SOUTH SAN I.S.D.

OLIVARES CAMPUS RENOVATION

# ADA NON COMPLIANCE REPORT

1ST FLOOR  
NTS

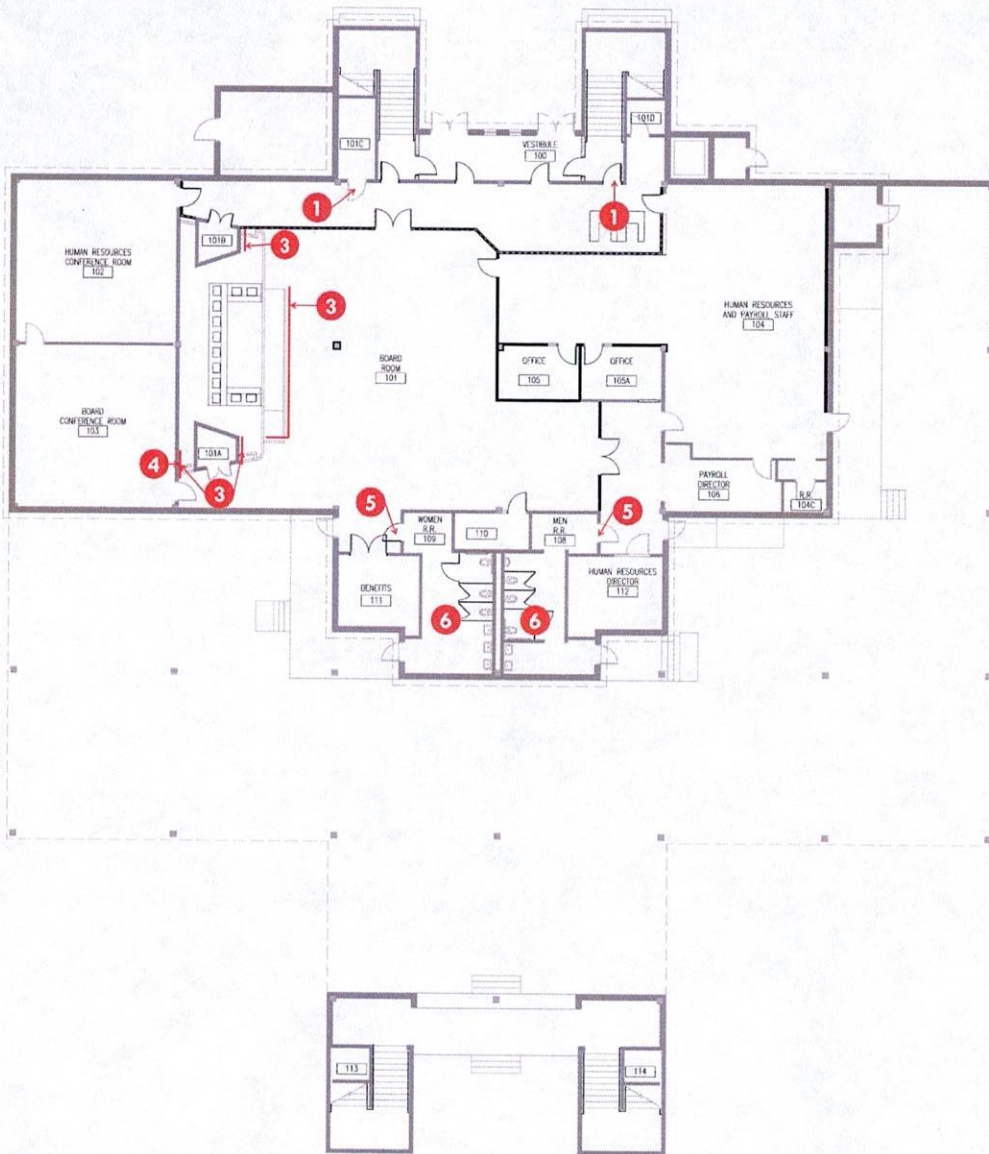
- 1.-APPROVE EXISTING PANIC HARDWARE AT DOORS.
- 2.- ALL EXISTING DOORS W/VISION PANEL- WIRE GLASS NO LONGER COMPLIES WITH CURRENT CODE..

- 3.- HANDRAIL IS REQUIRED AT STEPS & RAMP.
- 4.- SPACE ON BACK STAGE DOES NOT COMPLY.
- 5.- DOORS NEED TO BE RELOCATED TO COMPLY WITH 18" CLEAR APPROCH.
- 6.- HEIGHT AND LOCATION OF FIXTURES AND ACCESSORIES AT RESTROOMS NEED TO BE ADJUSTED
- 7.- REMOVE EXISTING DOOR.
- 8.- TURN INTO A SINGLE USE TOILET.
